FORM APPROVED
OMB NO. 1004-0135
Expires: July 31, 2010**SUNDRY NOTICES AND REPORTS ON WELLS**
*Do not use this form for proposals to drill or to re-enter an abandoned well. Use form 3160-3 (APD) for such proposals.*5. Lease Serial No.
NMLC055958

☒ Oil Well ☐ Gas Well ☐ Other8. Well Name and No.
STEVENS B 3

Burnett requests permission to deepen the Stevens B 3 well in the Loco Hills Yeso field in Eddy County to the base of the Yeso near 6100? TVD using United Rig #5.

**Stevens B 3
30-015-33132
Burnet Oil Co.
February 6, 2014
Conditions of Approval**

FIELD: LOCO HILLS PADDOCK WELL NAME: Stevens B 3 Proposed in Red FORMATION: Yeso
UNIT: E SEC: 13 GL: STATUS: Oil Well
TWNSHP/RANGE: T17S R30E COUNTY: EDDY KB: API NO: 30-015-33132
LOCATION: 2260' FNL & 990' FWL STATE: NM DF: LAT:
LONG:

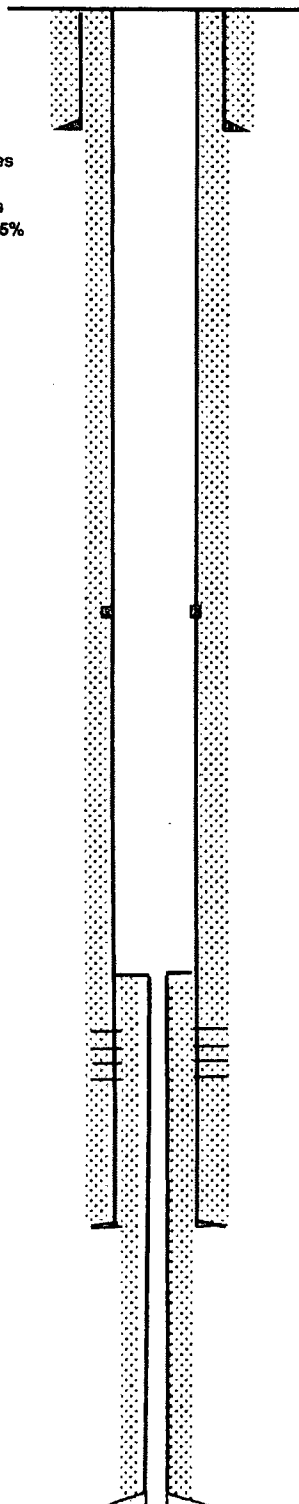
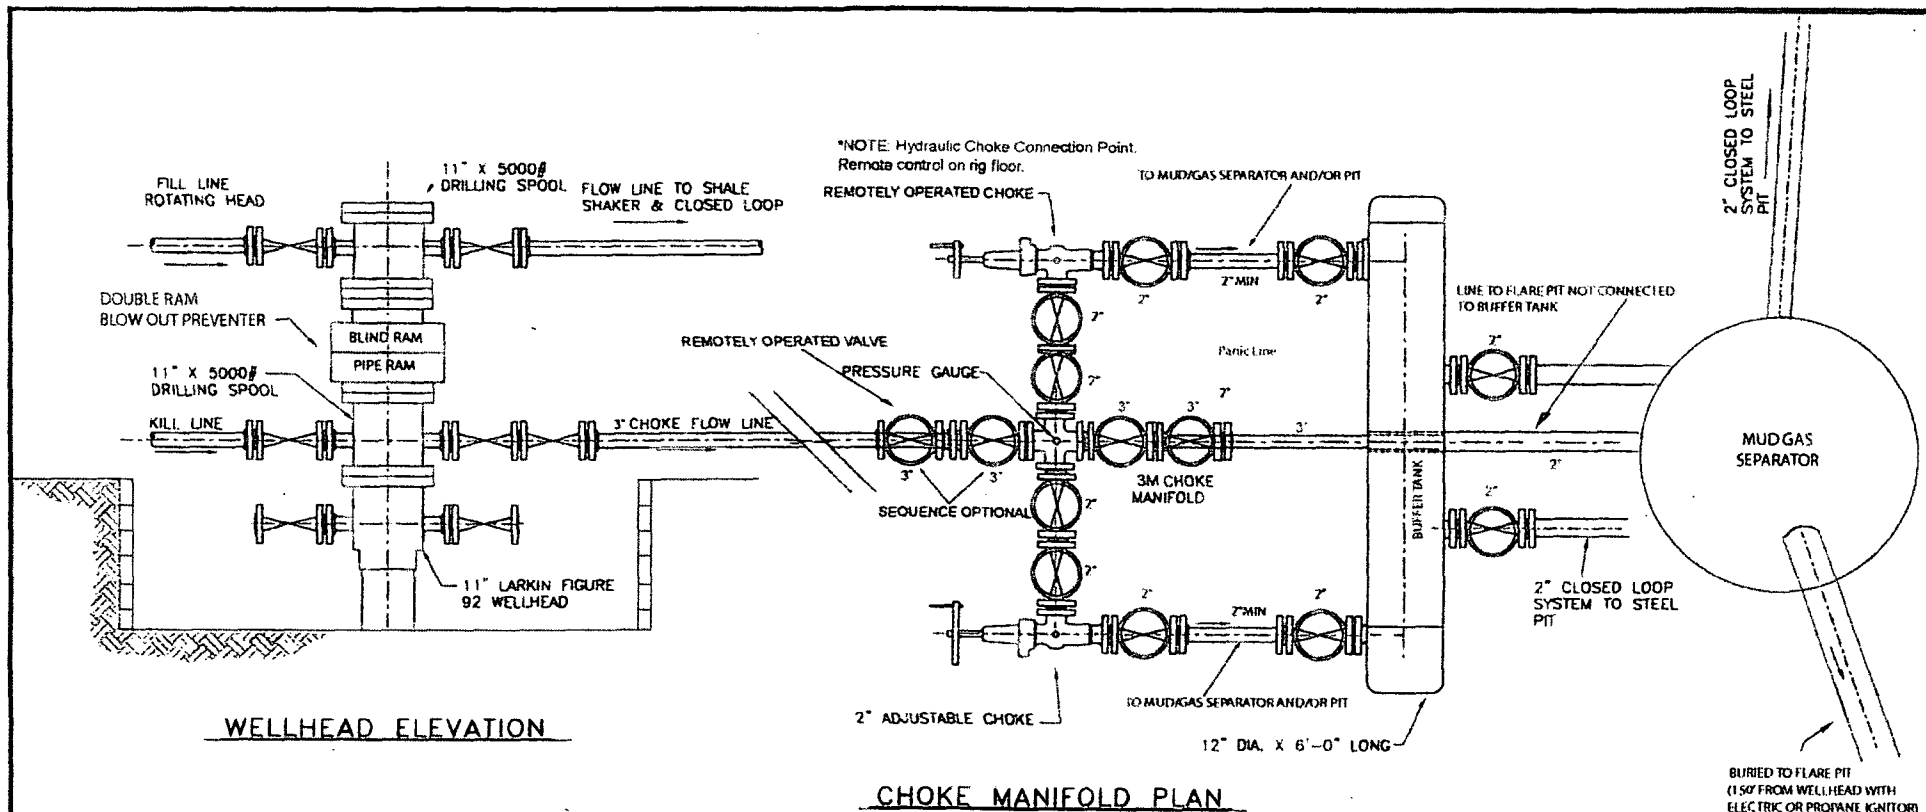
Please also see the proposed well bore diagram for this well.

Squeeze perms w/ 160 sx before deepening

1. Work to be complete within 180 days.
2. Surface disturbance beyond the existing pad requires prior approval.
3. Closed loop system to be used.
4. H2S monitoring equipment should be onsite for personnel protection from surrounding oil operations. Operator should not encounter H2S while deepening.
5. BOP to be tested to **3000 psi** based on BHP expected.
6. Variance for stand-off of less than 0.422" is approved due to NMOCD classifying the formations in this area as the Yeso group.
7. Cement on liner shall tie back to liner top, if this is not achieved contact appropriate BLM office. When plugged, cement plug will be required across this tie back and across squeezed perforations.
8. Test casing as per Onshore Order 2.III.B.1.h.
9. Subsequent sundry detailing work and current well test data are to be submitted when work is complete.
